Service Bulletin No. 59

TO: Parts & Service Managers
DATE: May 27, 1994
RE: Servo Motor Stripping Gears on:

TOMMY

Fig. 01

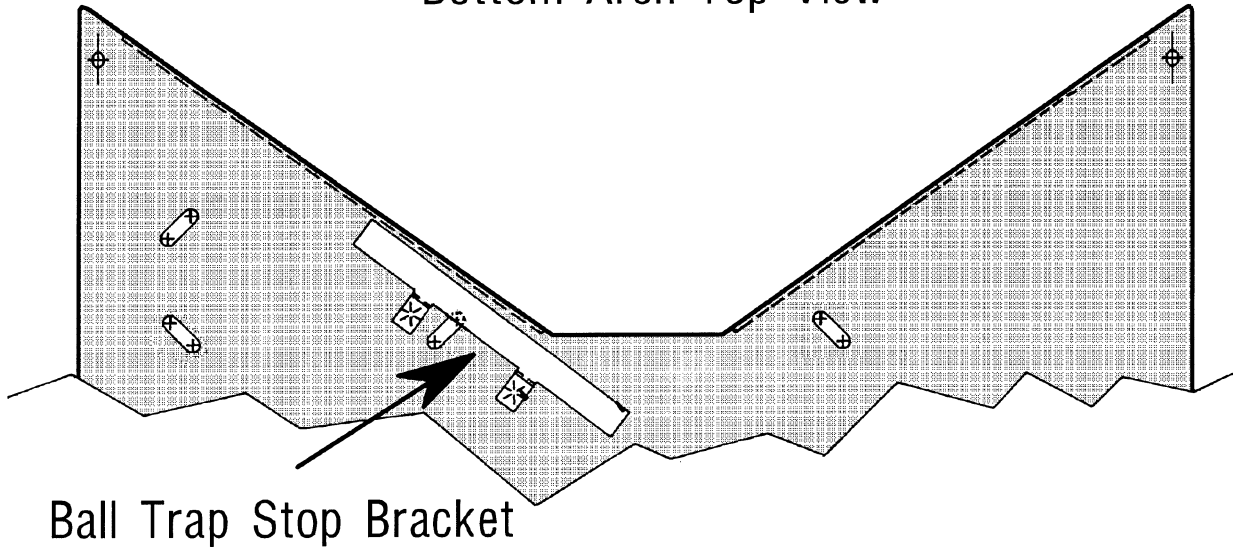
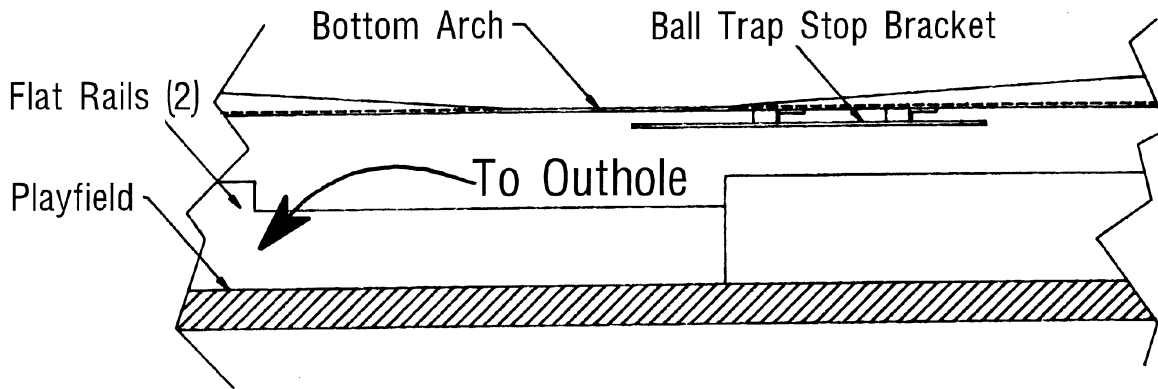
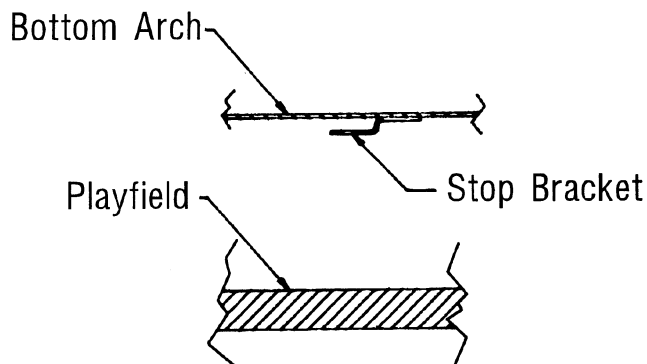
PROBLEM The Link Arm and/or the left blinder (top) blade is getting stuck on the underside of the playfield arch. There is a metal strip (bracket) spot welded to the under side of the arch, which protrudes down to prevent ball traps (See Fig. 01). This metal strip (bracket) is getting bent, when the playfield is being lifted by the arch, and in some cases the metal strip (bracket) gets bent downward. In either case this could cause premature failure to the servo motor, if binding occurs.

Inspect the underside of arch to ensure ball trap bracket is not bent. If bracket is bent adjust by re-bending the metal strip (bracket) according to the attached diagrams specifications. The specs. may vary depending on the particular arch assembly being used. The metal strip (bracket) should be parallel to the playfield with no bends.

Note: The Stop Bracket is parallel to playfield.
